To: All Plan Holders of Record

Re: *Addendum No. 1*
Lake County Executive Airport Terminal
Lake Development Authority

Date: June 17, 2024

1 FIRST FLOOR LIFE SAFETY PLAN
G0.11 1/8" = 1'-0"

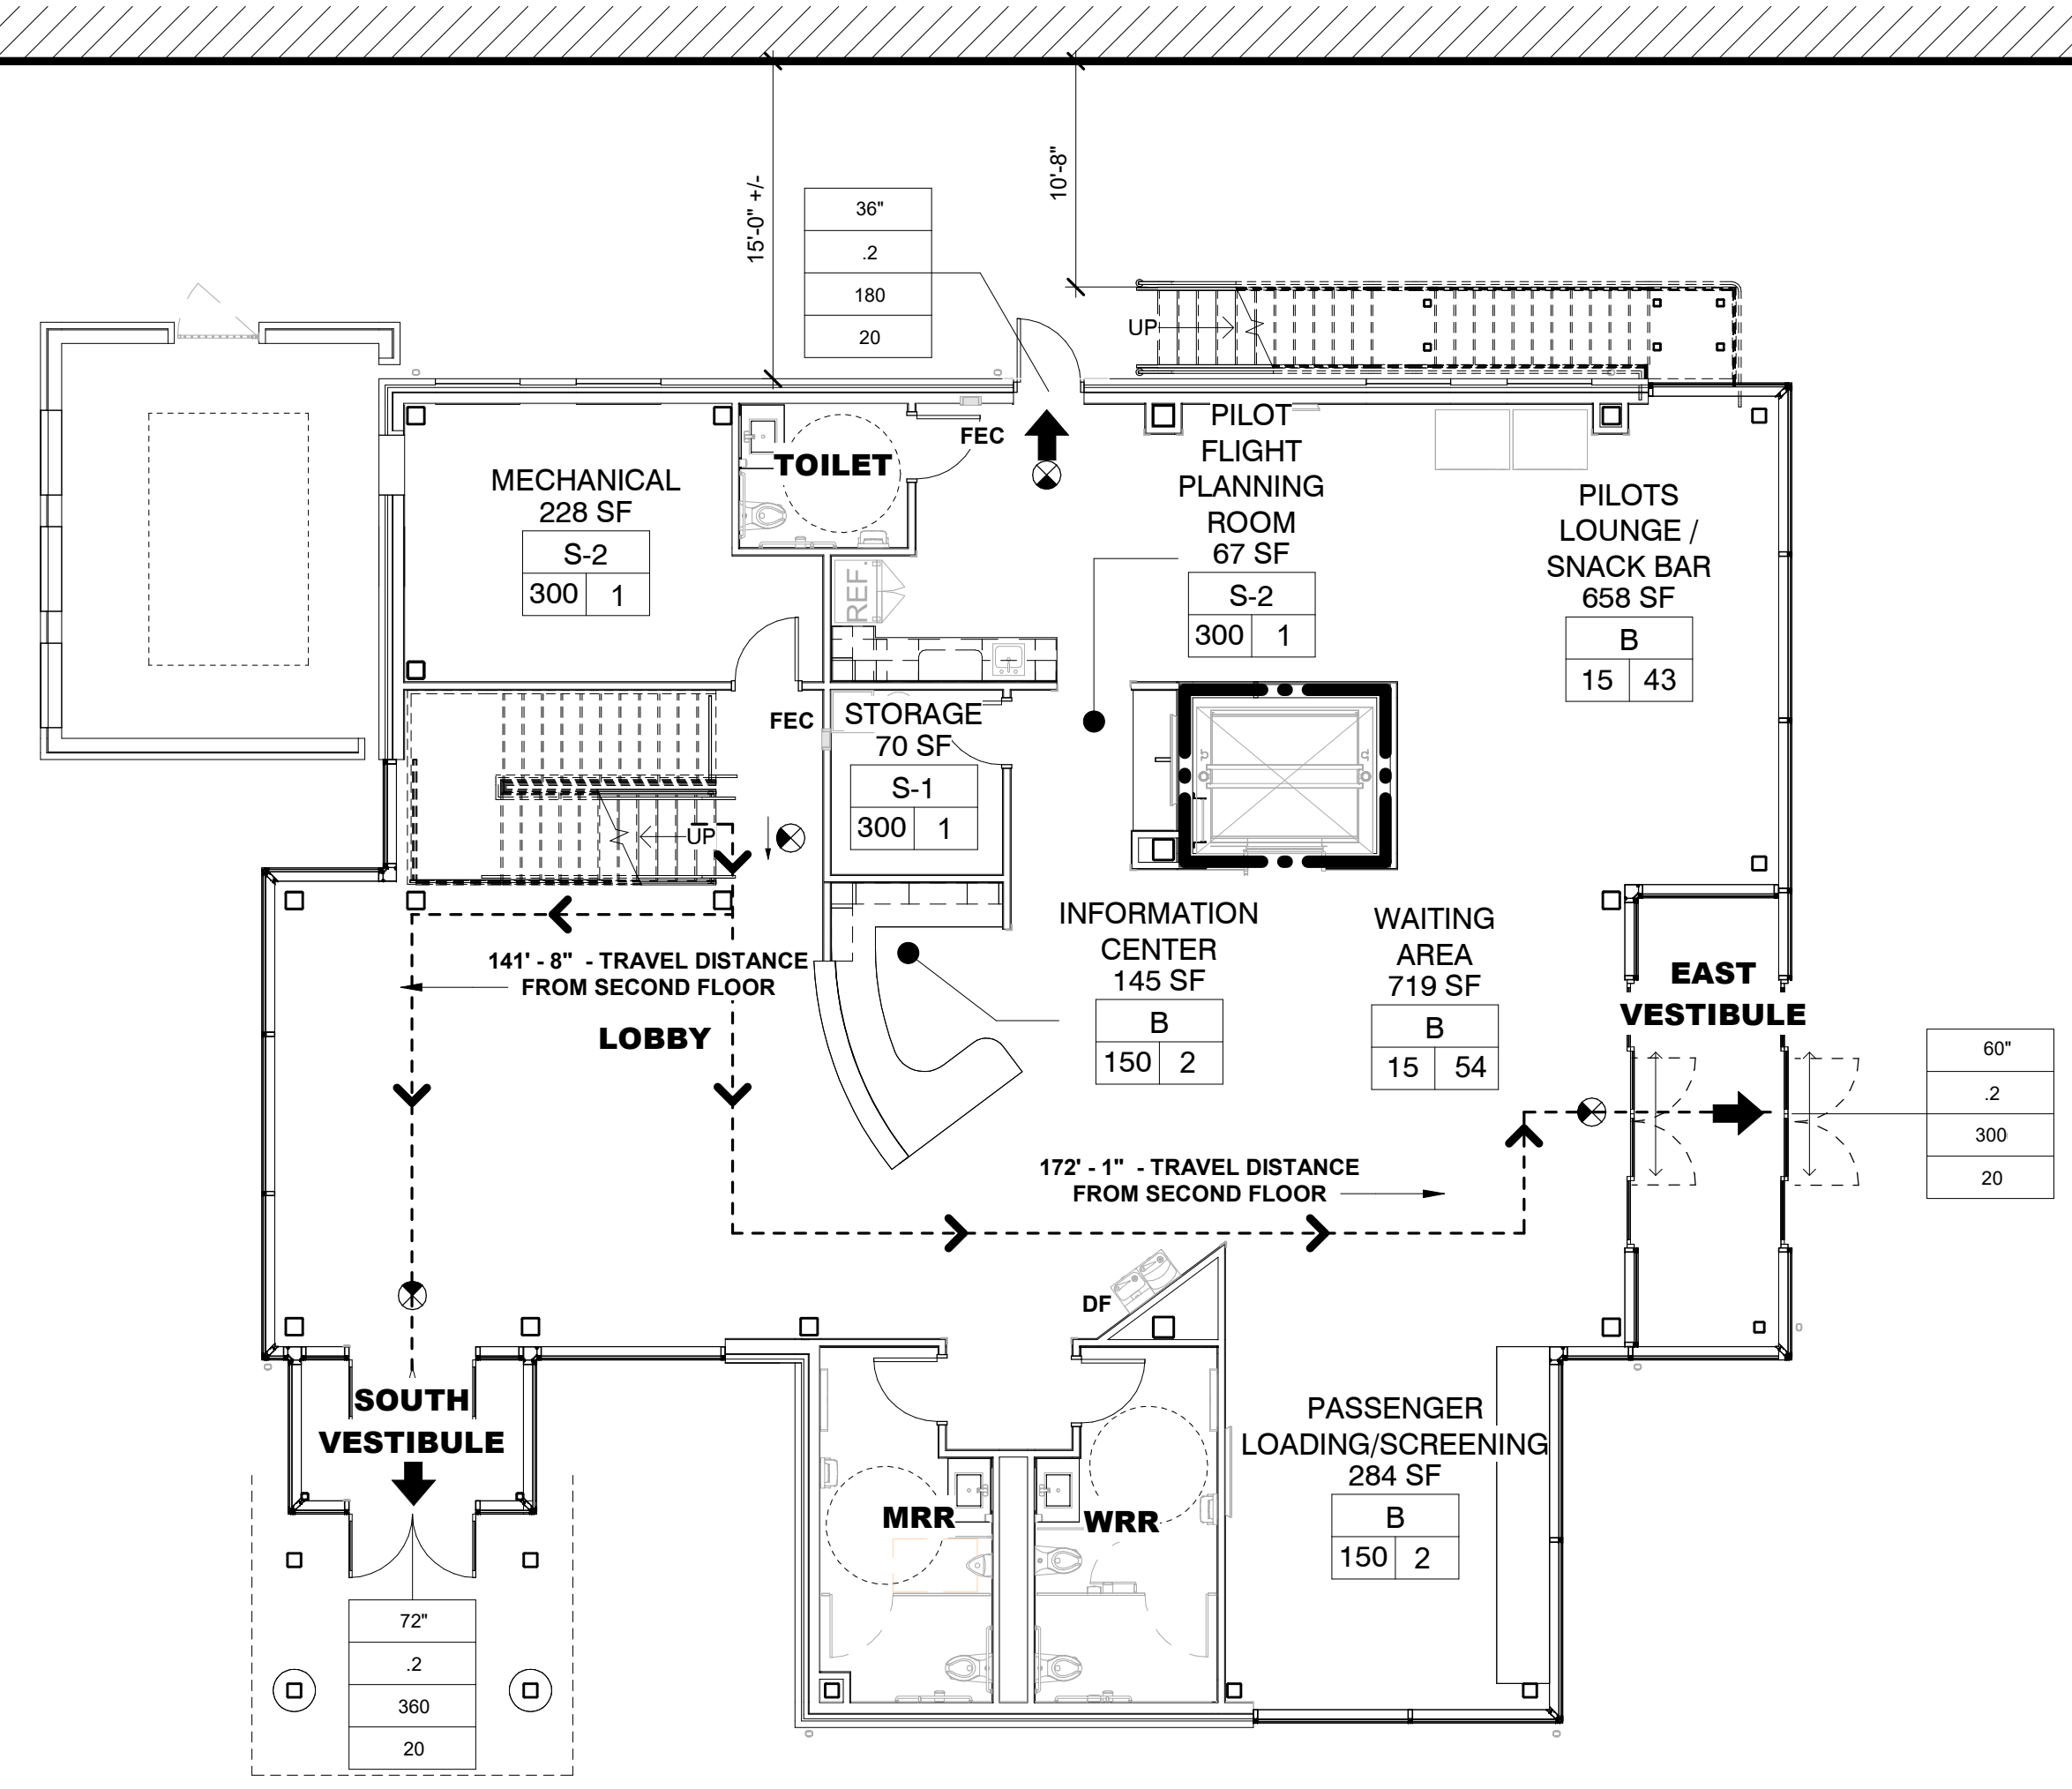
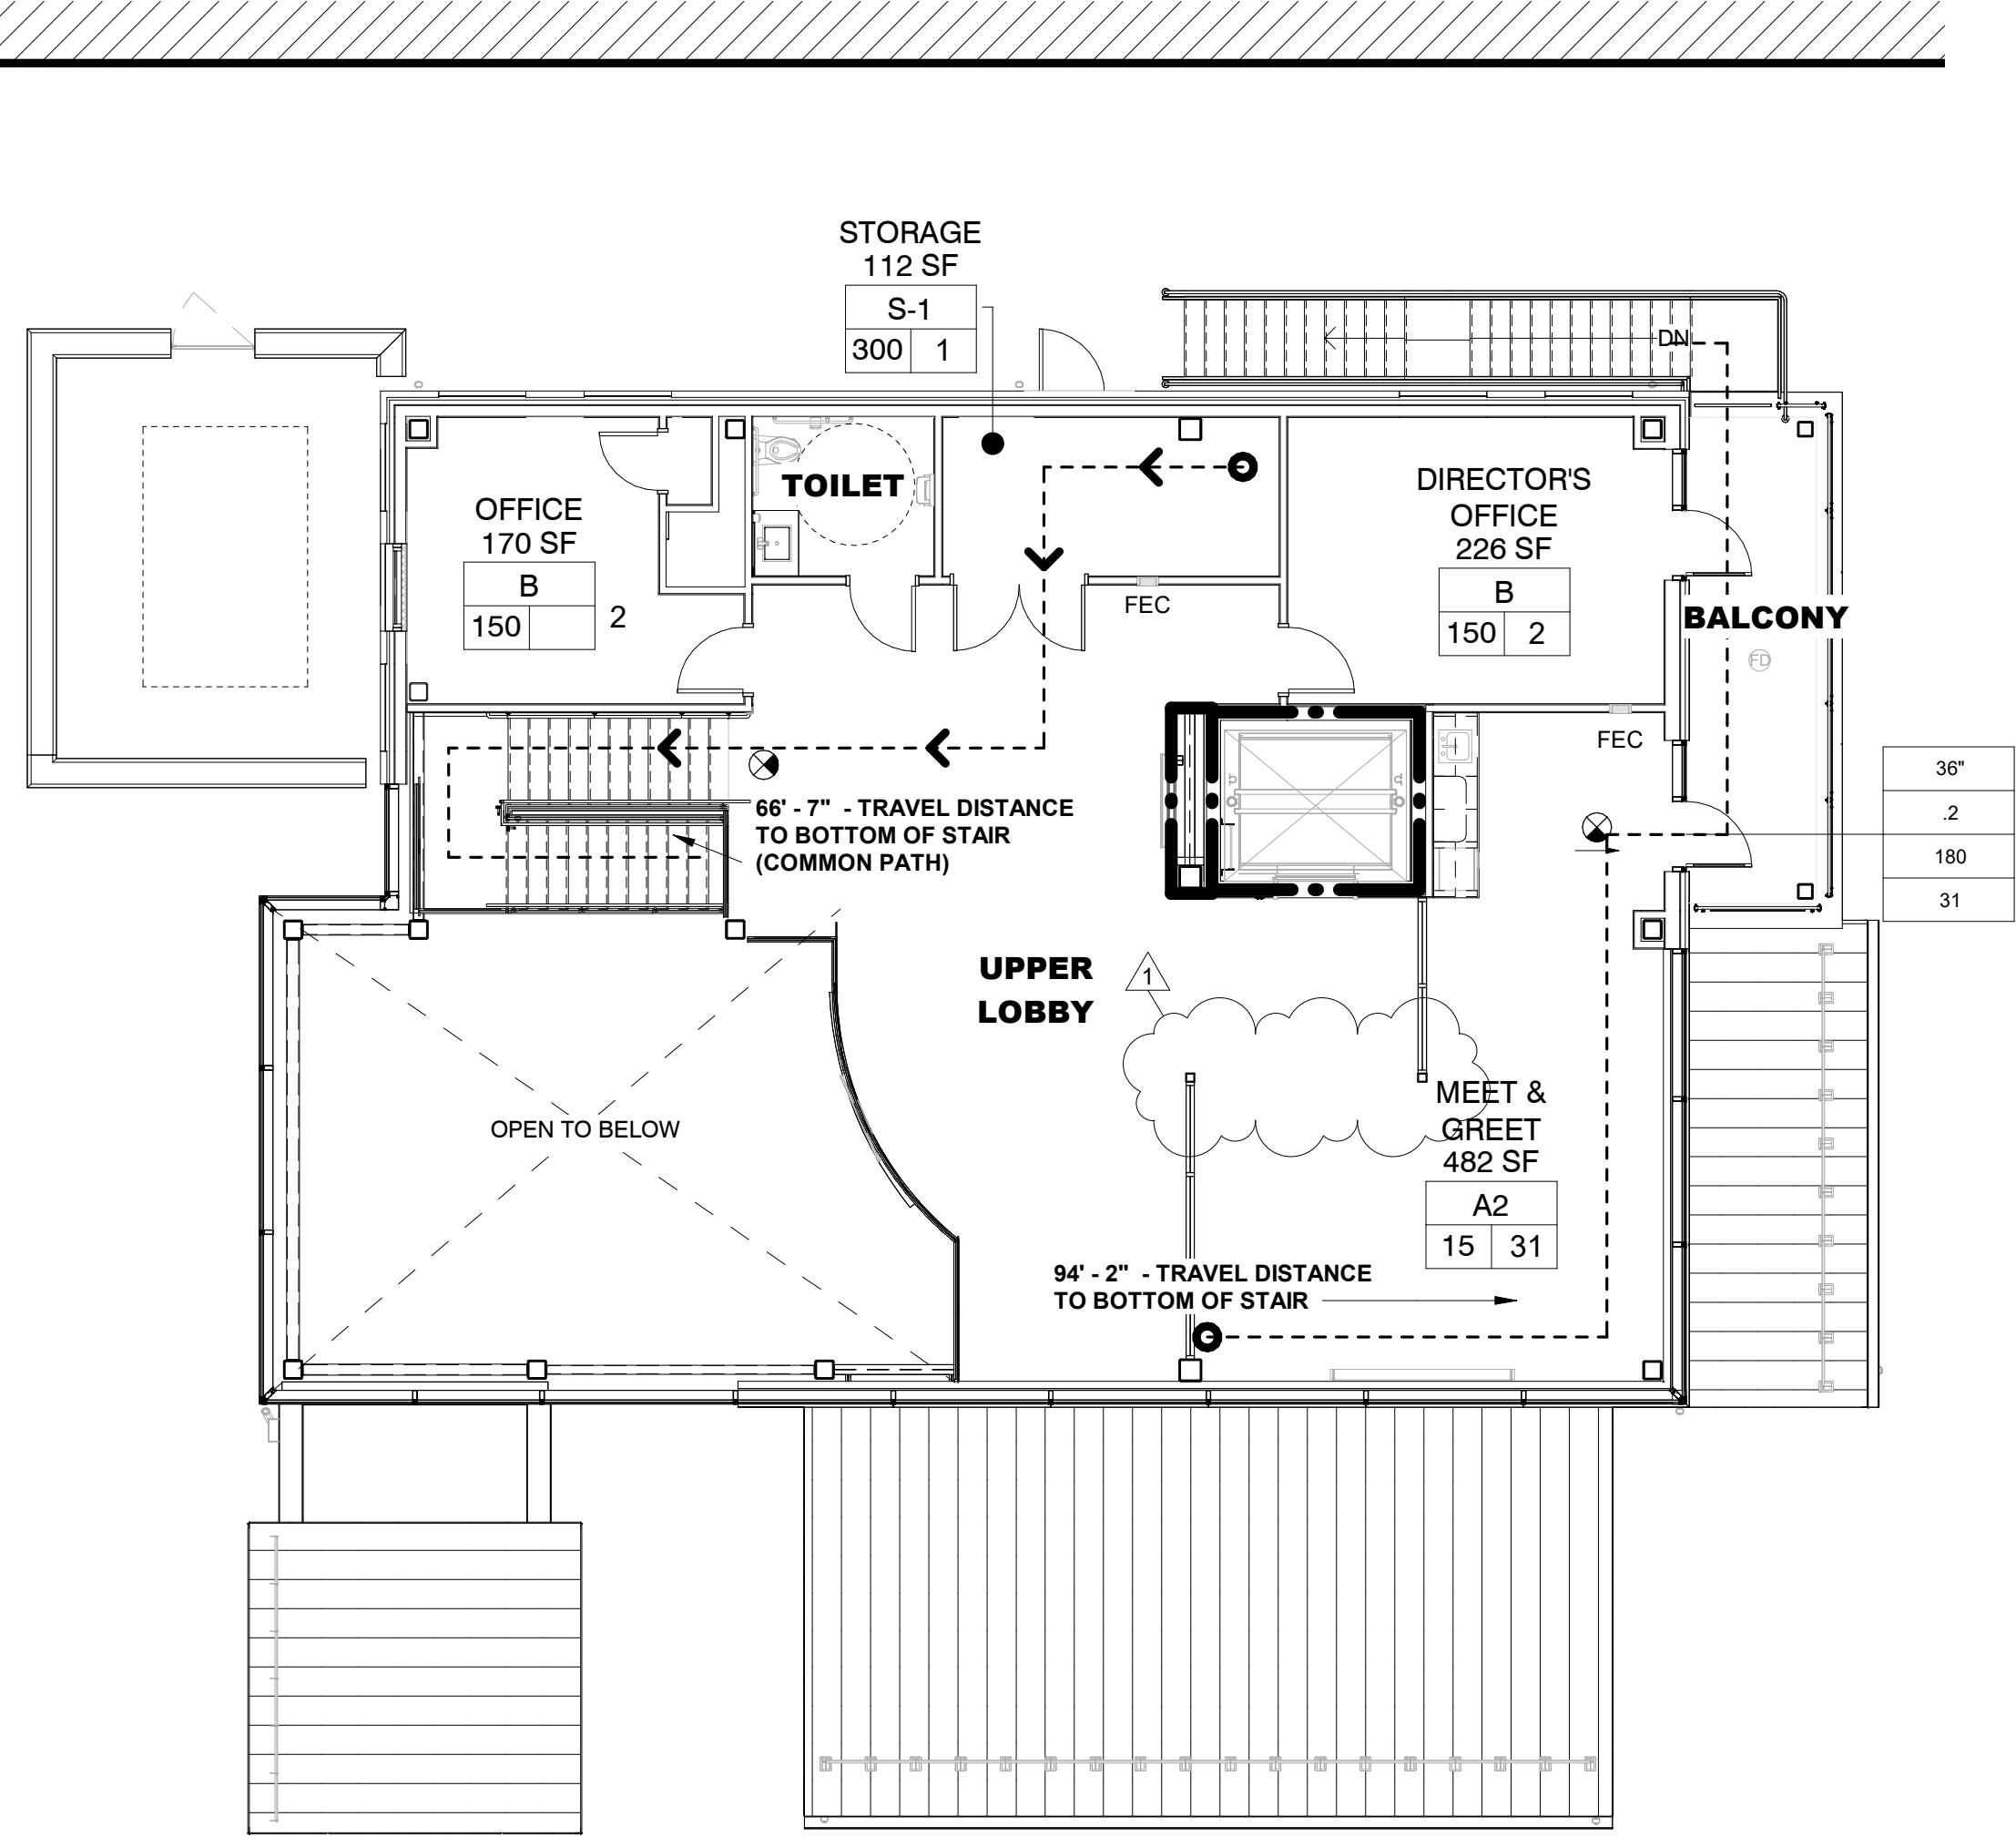
Reissued: G0.11 Removed storefront door and wing walls at the Meet and Greet area.
